**RE: Lot 7, Block 11 Volcano Cliffs Unit 18  
6524 Petirrojo Rd NW  
Grading and Drainage Plan  
Engineer's Stamp Date 4-20-16 (D10D003H6)**

Based upon the information provided in your submittal received 4/21/16, this plan is approved for Grading Permit and Building Permit.

ENGINEER'S SEAL	LOT 7, BLOCK 11, UNIT 18 VOLCANO CLIFFS SUBDIVISION	DRAWN BY JDG
	GRADING AND DRAINAGE PLAN	DATE 04-21-2016
		SHEET # 1 OF 1
4/20/16	 1606 CENTRAL AVENUE SE SUITE 201 ALBUQUERQUE, NM 87106 (505) 872-0999	JOB #
DAVID SOULE P.E. #14522

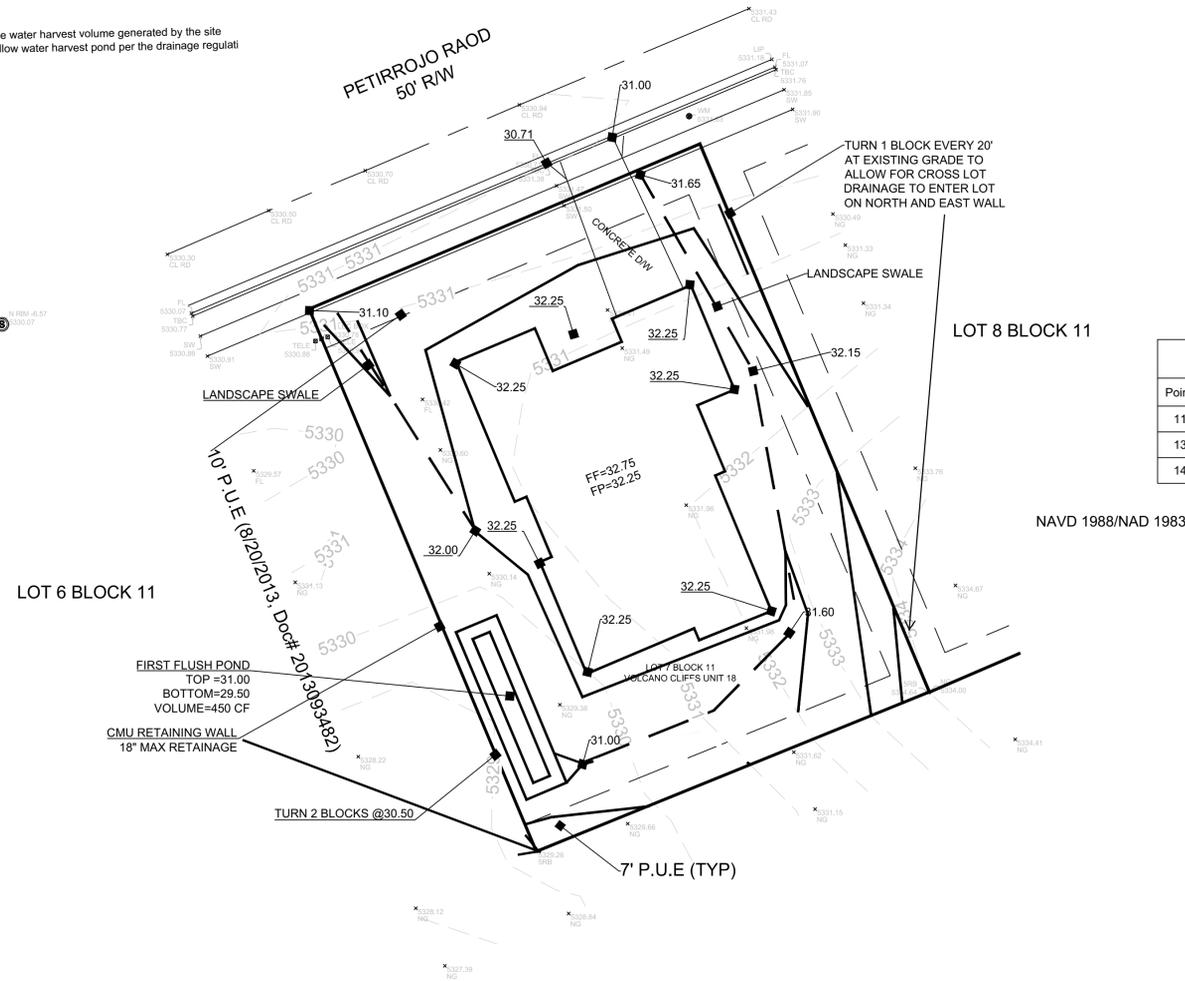
Please attach a copy of this approved plan to the construction sets in the permitting process prior to sign-off by Hydrology. A separate permit for the wall is required. Attach this approved plan to the wall permit set. Place all turn blocks 3" above grade for sediment control and landscaping.
